产品变更通知
Product Change Notification

PCN# 20201022001

产品名称 Product Name Surok Plus
产品P/N Product P/N C10-730186-()

图纸编号和版本 drawing No. & Rev. C10-730186-() cover assembly change potting to ultrasonic welding

C10-730186-()

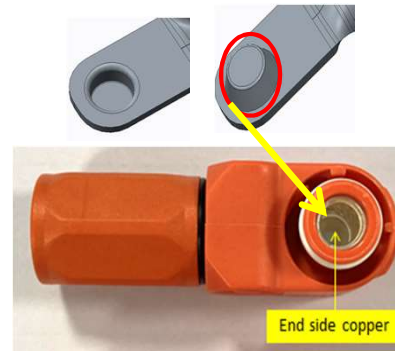
1. Current version, cover of 10-730186-() assembly by potting way, easy bring appearance problem when glue spills over the cover surface, which also cause scrap problem as the bad appearance, and this assembly will lower work efficiency.

2. Plastic shell have no date code, to track product will need to link to package in shipment

3. Cover assembly using potting way also request metal part add "cavity" design to stop glue get into inside socket contact.

1. Cover of 10-730186-() assembly change to ultrasonic welding, can reduce appearance problem, improve work efficiency when keep the function no change.

2. Plastic shell add date code, easier for the production date tracking

3. Change cover assembly from potting to ultrasonic welding, no glue involve, "cavity" in socket backend not need anymore for stoping glue get into socket contact, which can removed "cavity" in backend for cost saving, and improve work efficiency.
